**Revised Phase B Site Investigation
Work Plan
Text, Tables, and Figures**

**Tronox LLC Facility
Henderson, Nevada**

AECOM, Inc.
December 2008
Document No.: 04020-023-430

Subject: Revised SAP Tables, Figures and Plates for the Phase B Source Area Investigation Work Plans for Areas I, II, III and IV, Tronox LLC Facility, Henderson, Nevada (Facility # H-000539)

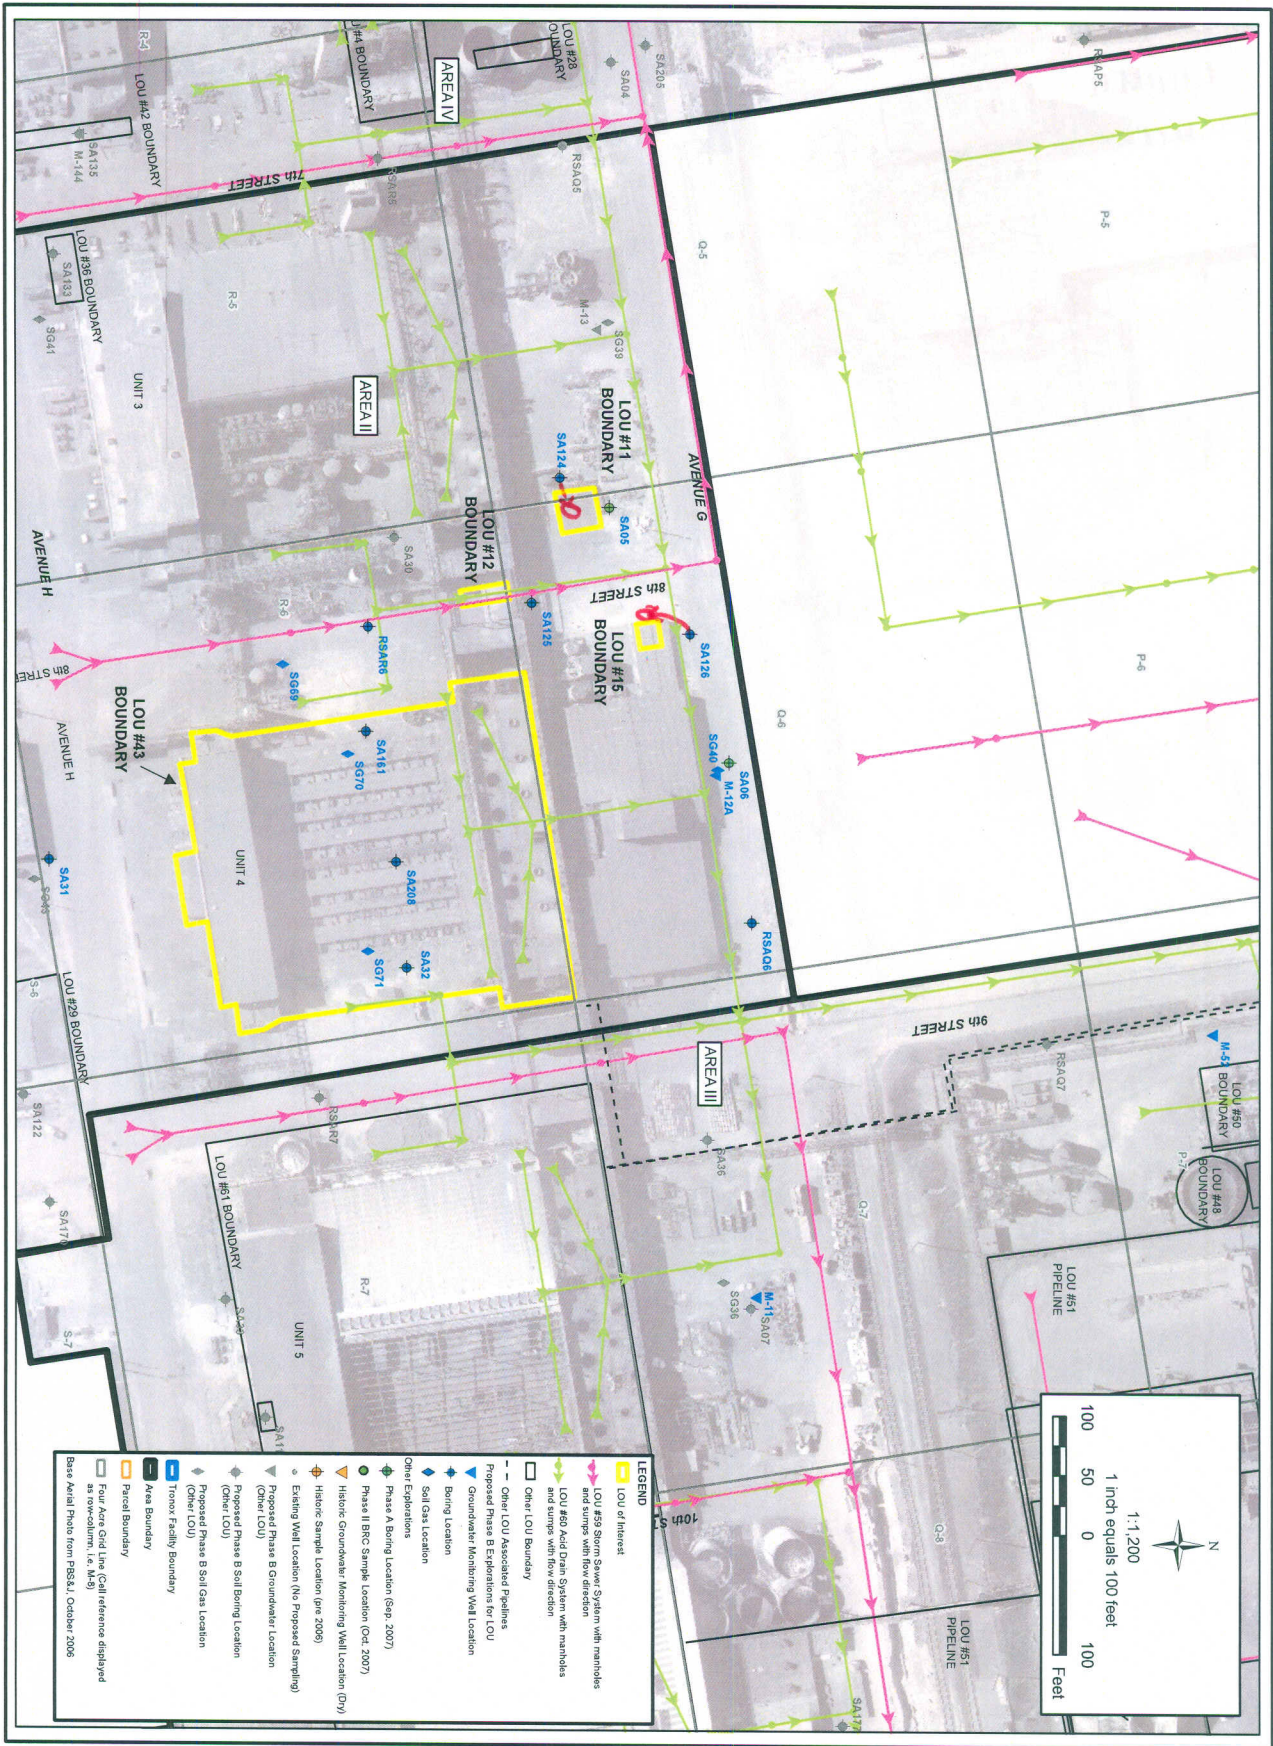
• move SA124 into LOU11
 • move SA126 adjacent to LOU15 to the west.

SHEET NUMBER	1
FIGURE NUMBER	X

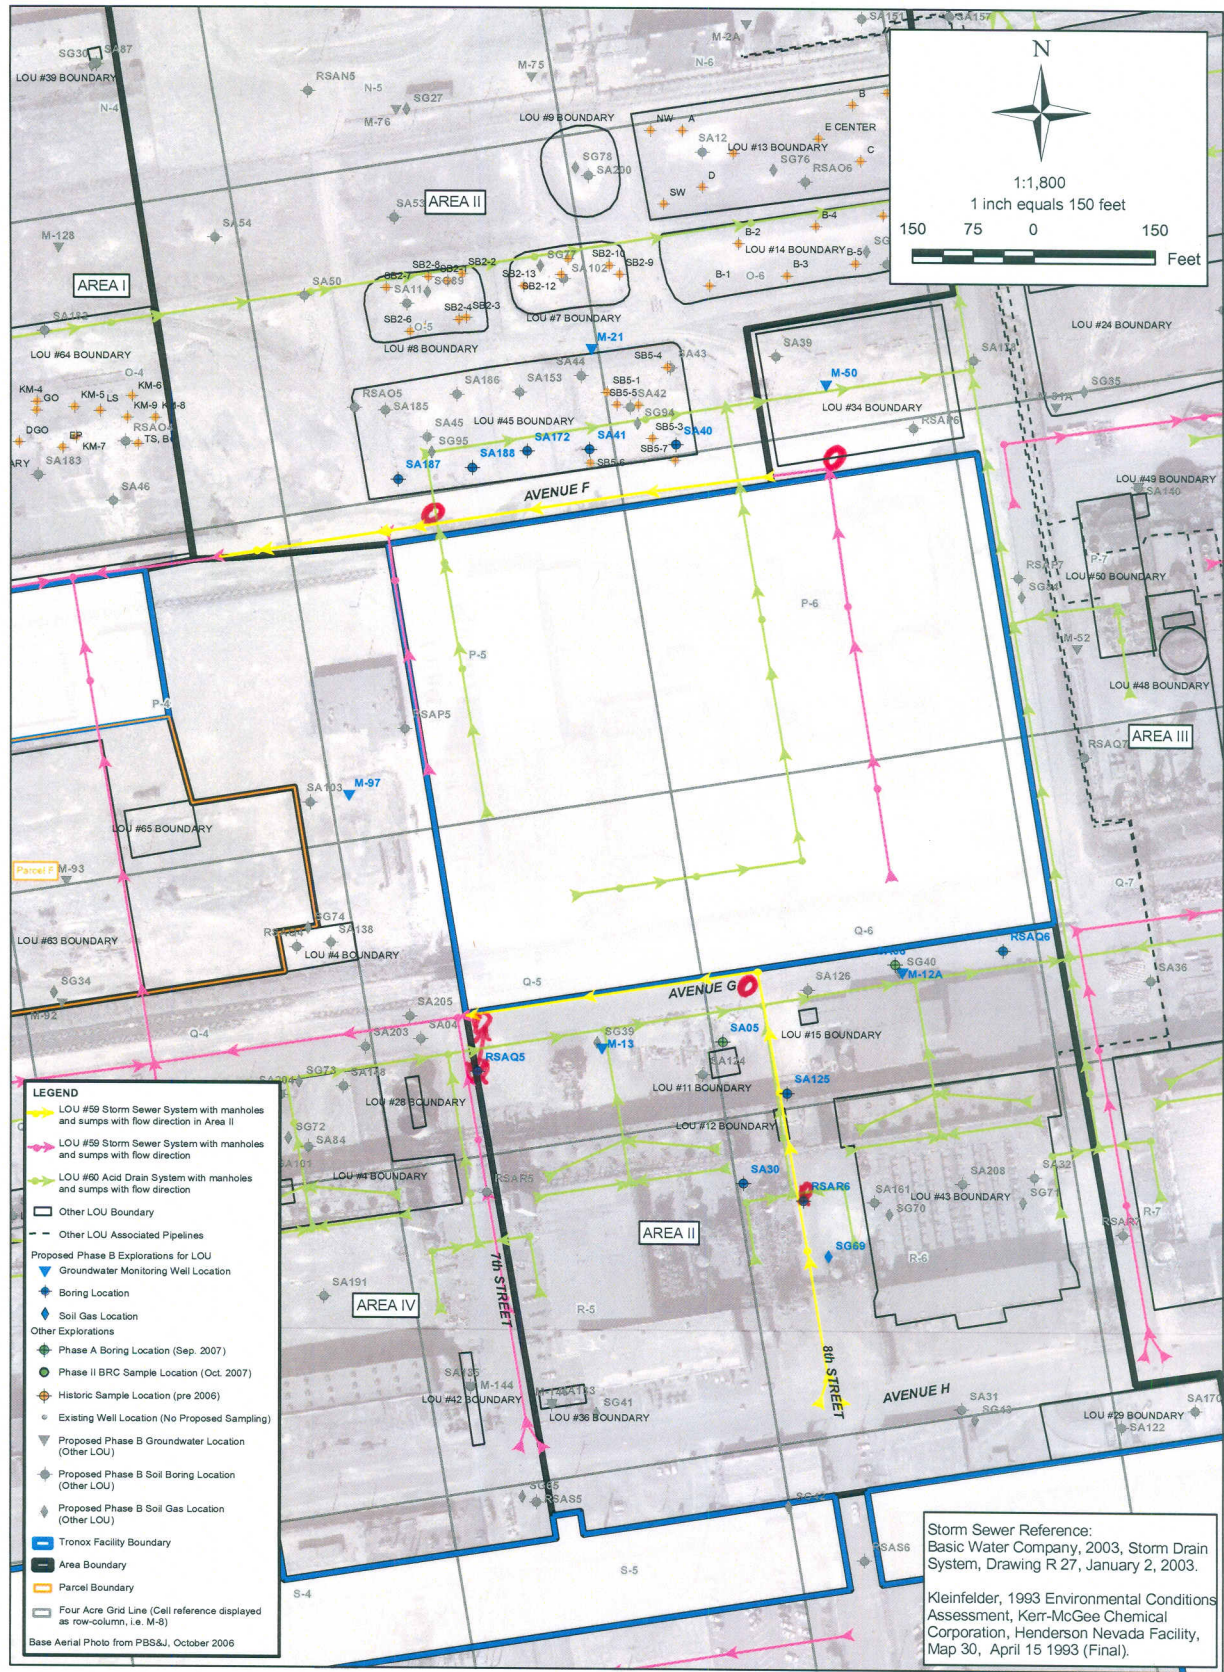
additional boring
 additional boring
 move RSAOS to south of Chemstar
 North of Chemstar, south of Lou 45, over Lou 60
 North of Chemstar, south of Lou 34, at 90° turn
 south of Chemstar, at 90° turn
 south of Chemstar, at 90° turn
 adjacent to Lou 59
 move RSA B6 overlaid

SHEET NUMBER:	X
FIGURE NUMBER:	1

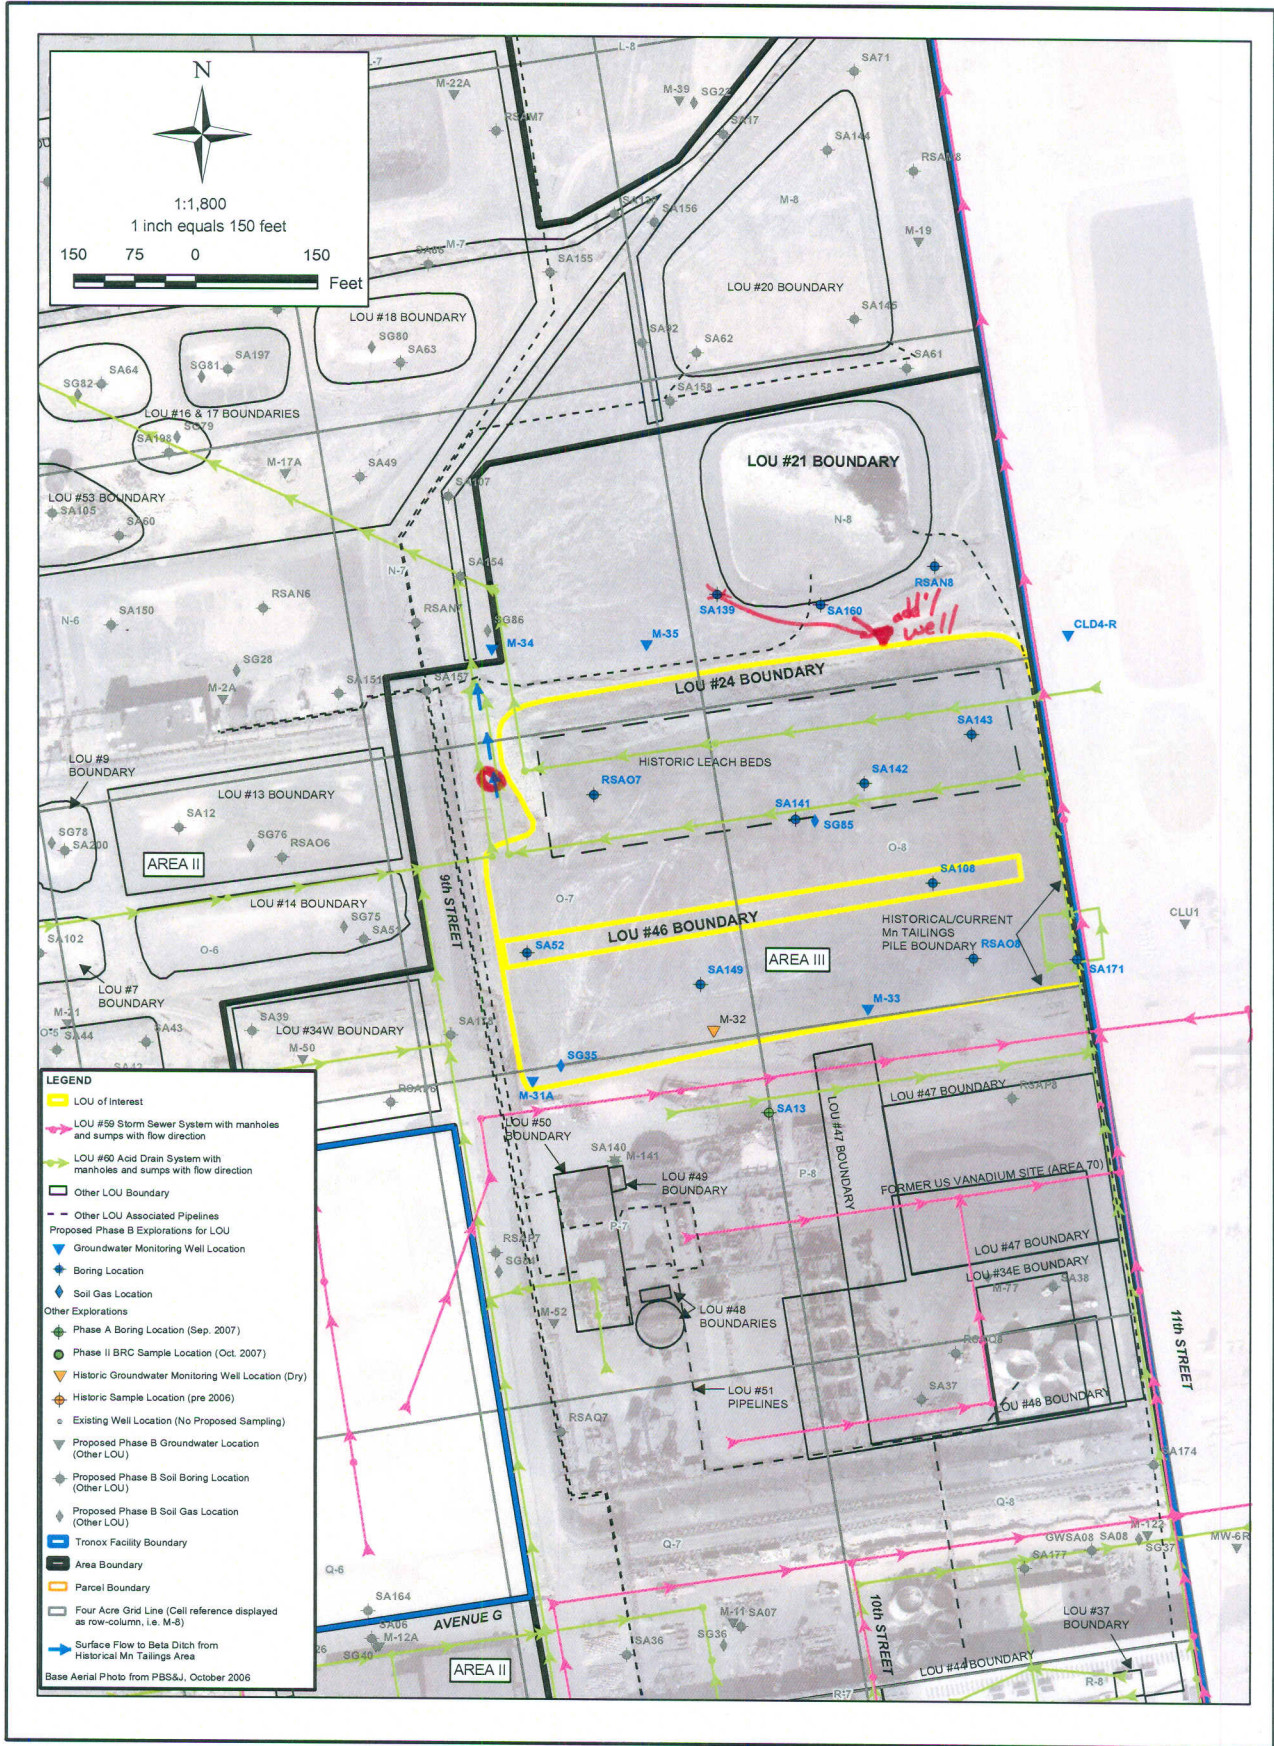
*additional boring located in surface flow from MN TAILINGS Area
 move SA139 to just north of LOU 24 & convert to monitoring well.*

SHEET NUMBER	1
FIGURE NUMBER	X

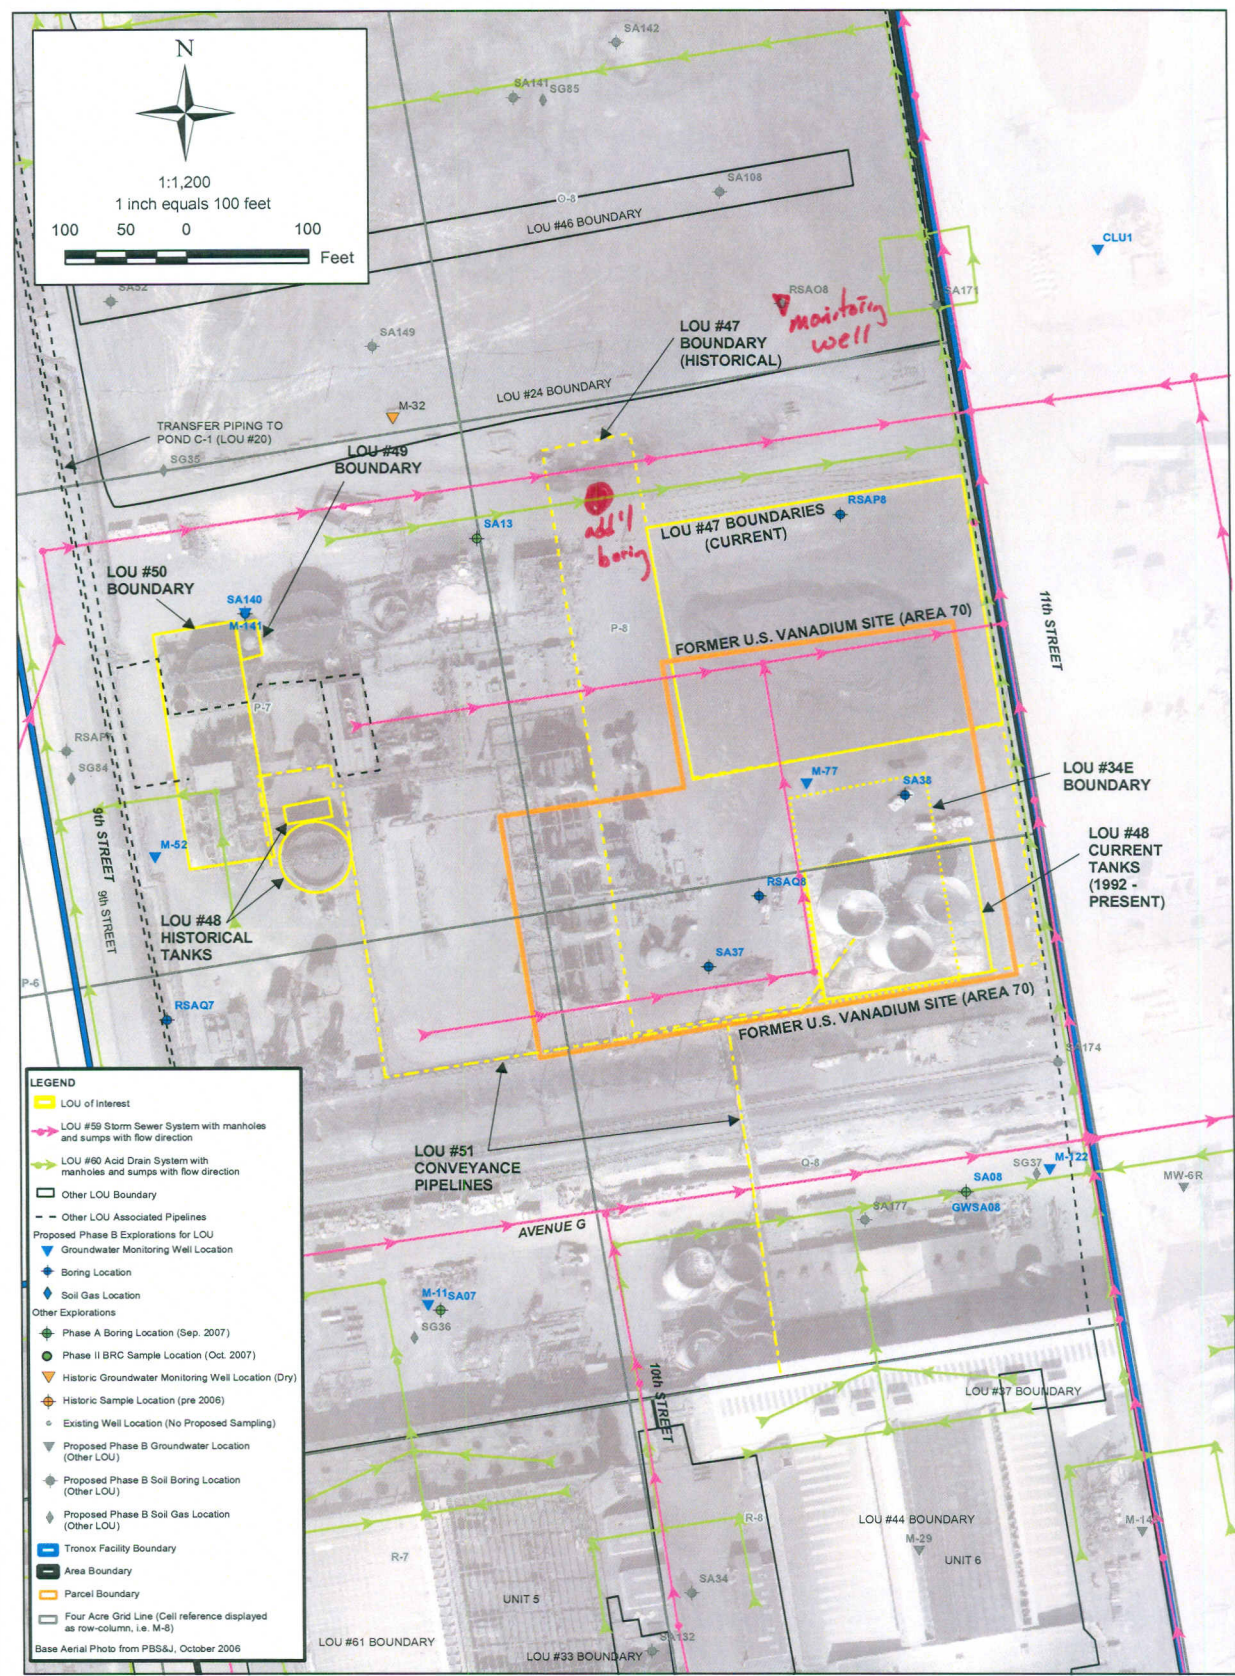
Additional boring on LOU 60 in northern portion of historical land. Convert RSA08 to monitoring well.

SHEET NUMBER:	X
FIGURE NUMBER:	1

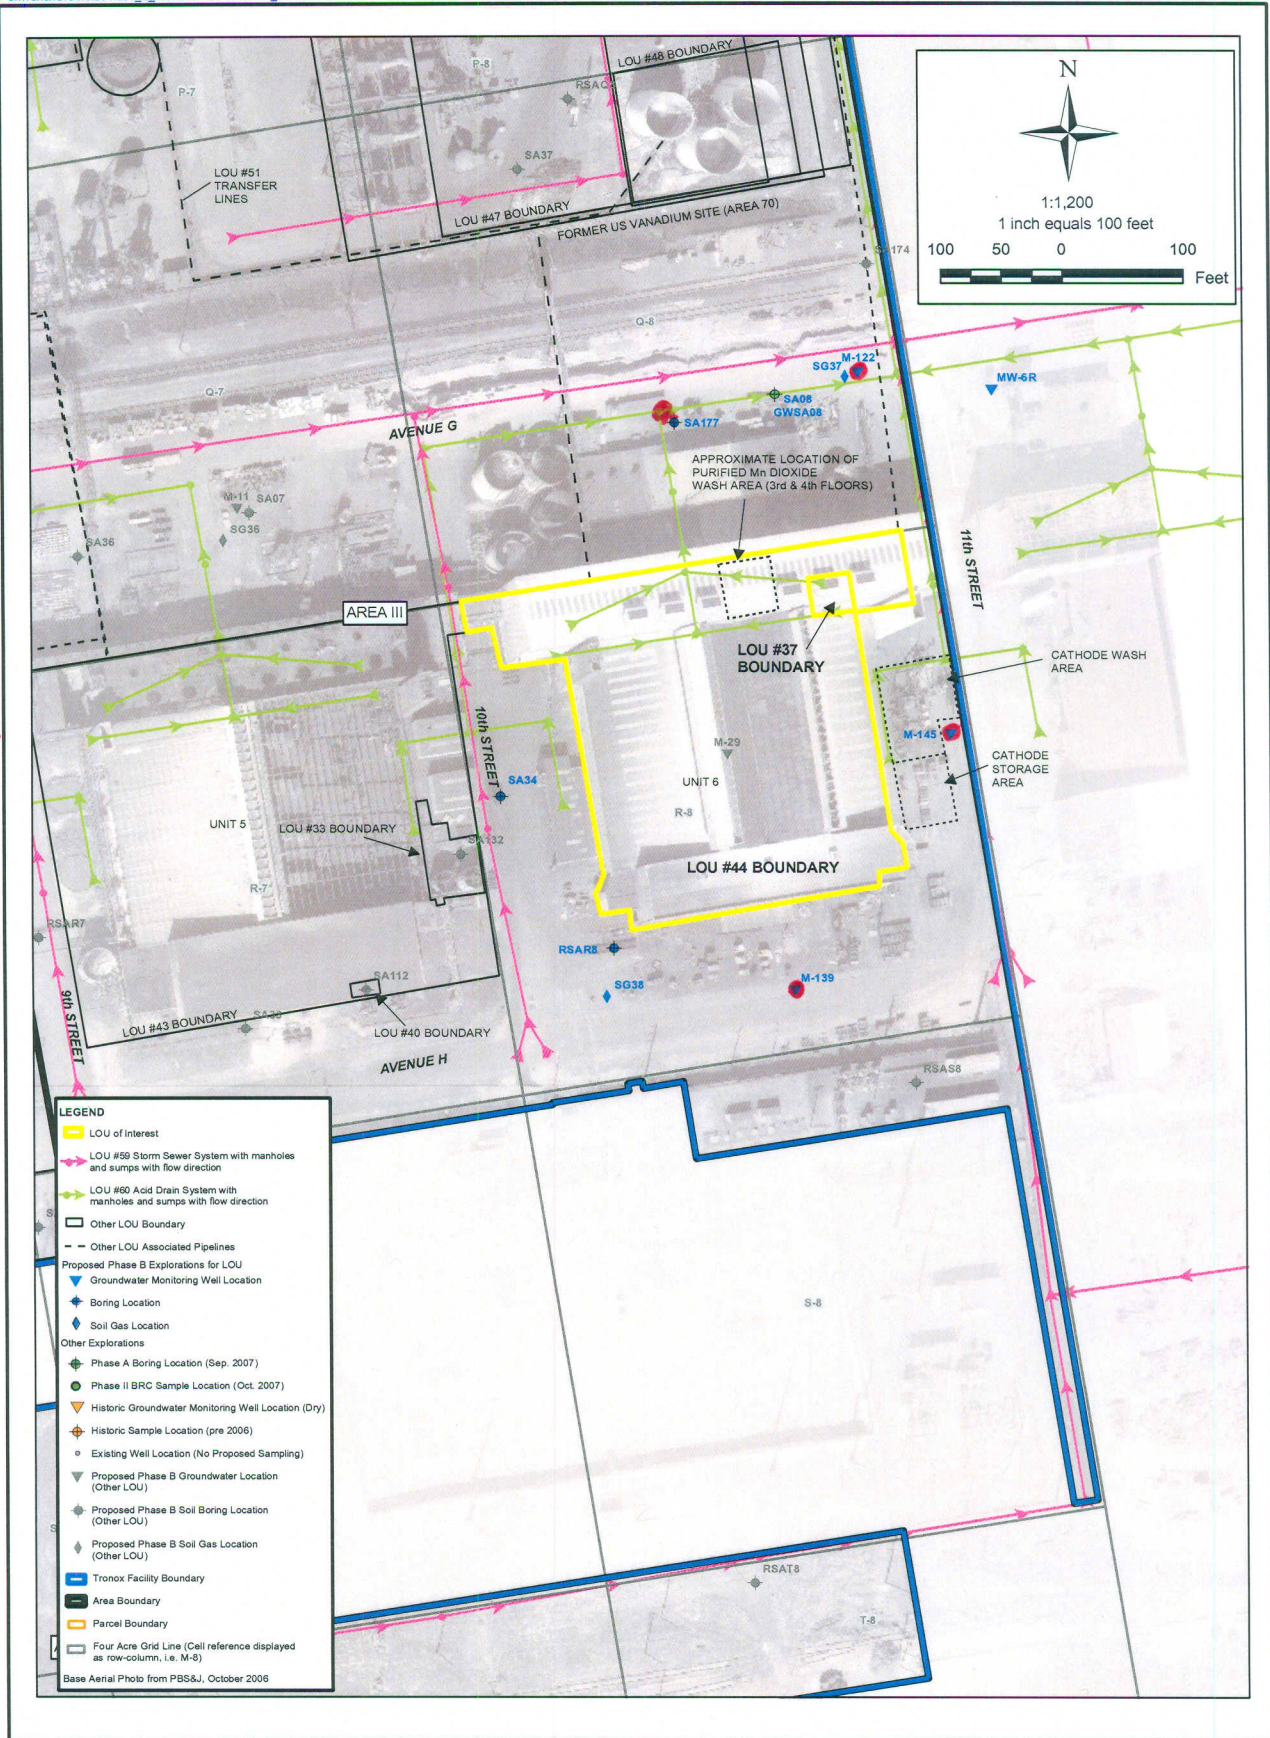
SA177 move to intersection/junction LOU 60.
Add borings collect samples for M-122, M-145 & M-139
